Water and wastewater servicing of the West Dapto Urban Release Area and Adjacent Growth Areas

Submissions Response Report

Figure 3-9 Ammonium loads per event at high and highest priority directed overflows

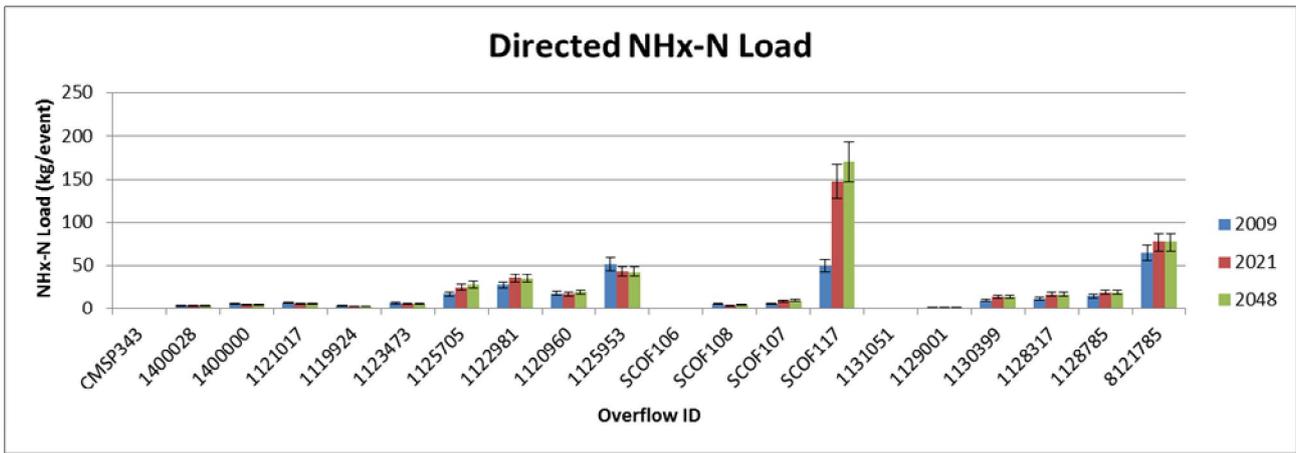
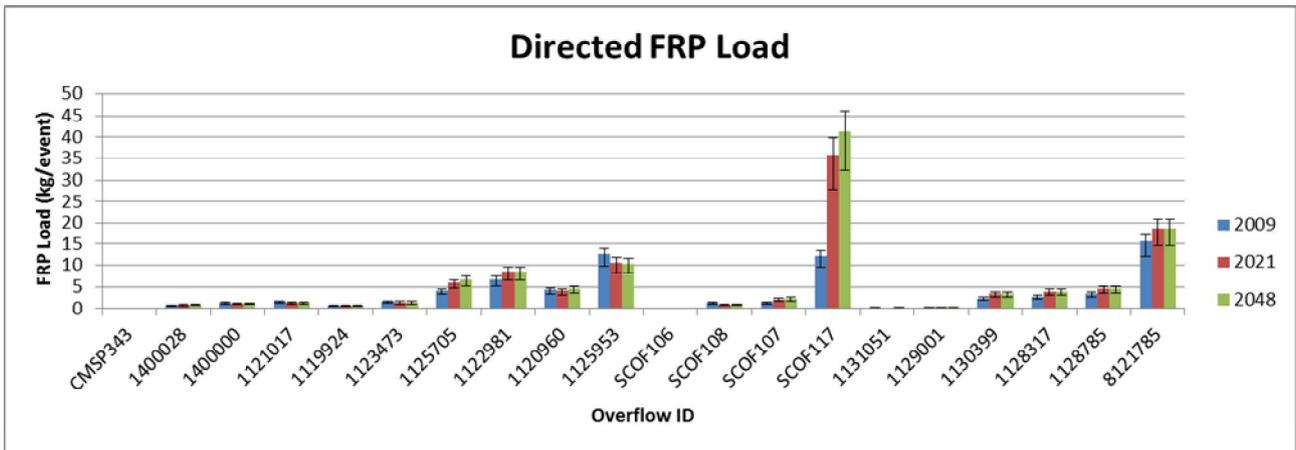
Issue - The proportion of stormwater and wastewater overflow load estimates for nutrients that are biologically available should be defined

Sydney Water calculated the proportion of biologically available nutrients in wastewater loads, based on typical concentrations found in wastewater (Table 3-1). Event loads for ammonium and filterable reactive phosphorus from directed overflows were considered to be high and highest priorities are shown in Figure 3-9 and Figure 3-10. The results are similar to those reported in the EA (Appendix C of Appendix D) as directed overflows that have the greatest volume per event. Total nitrogen and total phosphorus loads also have the greatest proportion of ammonia and filterable reactive phosphorus. The key difference is that the majority of total phosphorus and total nitrogen is represented by bioavailable forms as ammonium and filterable reactive phosphorus.

Wastewater typically contains no oxidised nitrogen as it is in a reducing environment (lack of oxygen) when it is within the pipelines. As total nitrogen within wastewater is represented by organic and ammoniacal nitrogen, un-oxidized nitrogen has not been considered. Once wastewater is discharged into the environment, the process of oxidation depends on a range of conditions, including the nature of the receiving environment and presence of suitable bacteria.

We calculated the loads of biologically available nutrients in stormwater and compared them to wastewater. Figures 3-11 to 3-13 display the annual pollutant contribution from stormwater and wastewater on a sub-catchment scale for ammonia, filterable reactive phosphorus and oxidised nitrogen. Overall, stormwater contributes greater loads of ammonium and filterable reactive phosphorus compared to wastewater. The confidence levels also indicate that stormwater loads show greater variation.
